Brief Supporting the Motion for Six Material Actions to be completed by Sio Silica and Section 35 Indigenous Consultation to be held before continuation of CEC Hearing

**D. M. LeNeveu, M.Sc. Bsc.(hons. physics), B.Ed., former Member of Canadian Society of Safety Engineering
Oct. 20, 2022**

Figure 6. Acrylamide concentration in Sio Silica Slurry loop

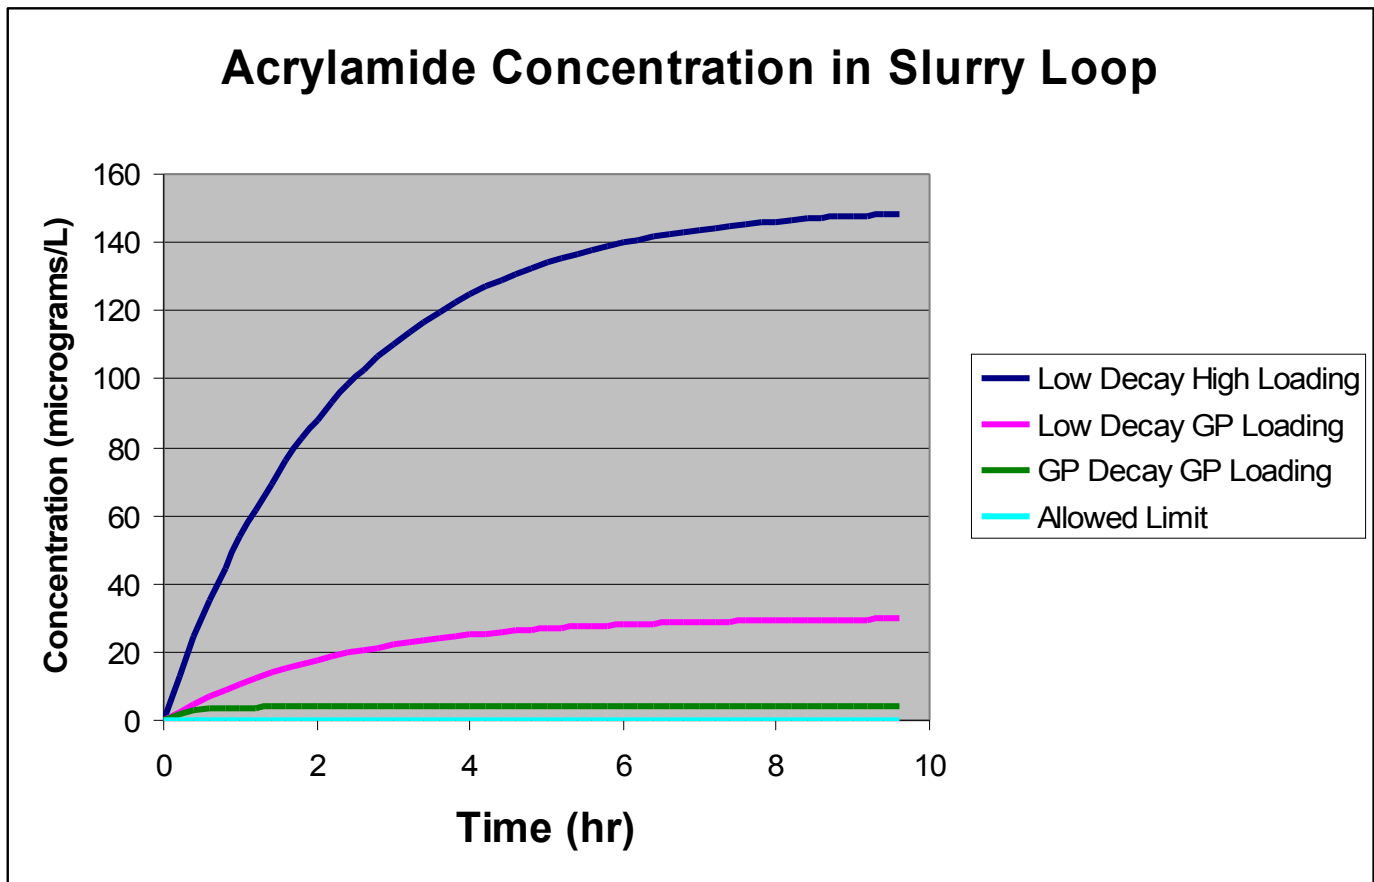
Figure 6 illustrates the acrylamide concentration would rise to steady state values above the allowed limit in the Sio Silica slurry loop in a matter of hours. “Loading” in the legend of figure 6 refers to the mass loading rate of the acrylamide monomer in the clarifier tank of the slurry loop. “GP” indicates Great Plains values.

The loading of the acrylamide monomer used here does not include degradation due to dissolved oxygen and Fe^{2+} as documented by Xiong et al., 2018¹⁰. Degradation would result in much higher dissolved toxic acrylamide concentrations.

Remediation by a contaminant removal process such as reverse osmosis would be required to operate continuously. Sio Silica must specify the volume, disposal method and disposal location of the concentrated waste stream for acrylamide removal.

Figure 7. Selenium concentration in the Sio Silica wash plant and slurry loop water

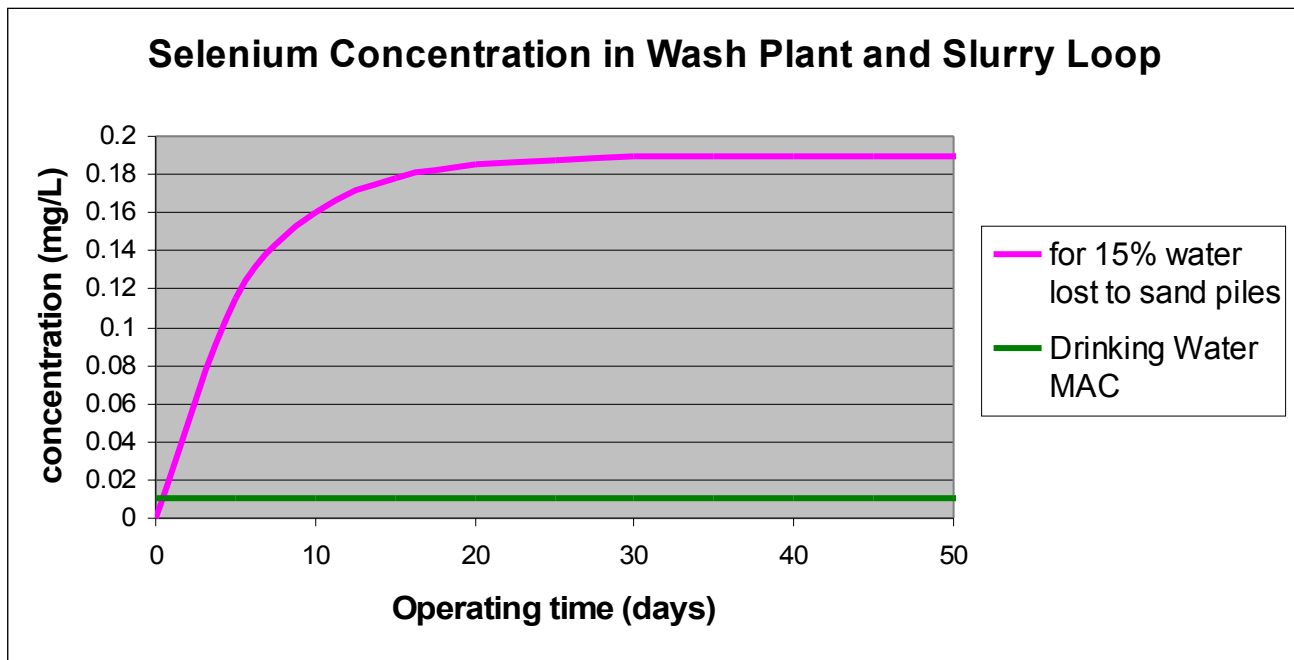
Figure 7 illustrates the selenium concentration in the slurry line loop as a function of time for a zero initial concentration of selenium in the water entering the slurry line, Q_L of 23.7 m³/hr, M_s of 4.41 g/hr and V_p of 1325 m³ for the water loss, Q_L , determined for 15% water loss to sand stockpiles.

Figure 7 illustrates that the selenium concentration would rise to steady state in the slurry loop and wash plant in about 20 days and would exceed drinking, irrigation and aquatic life water guidelines in a matter of hours. Remediation by a contaminant removal process such as reverse osmosis would be required to operate continuously. Sio Silica must specify the volume, disposal method and disposal location of the concentrated selenium waste stream.
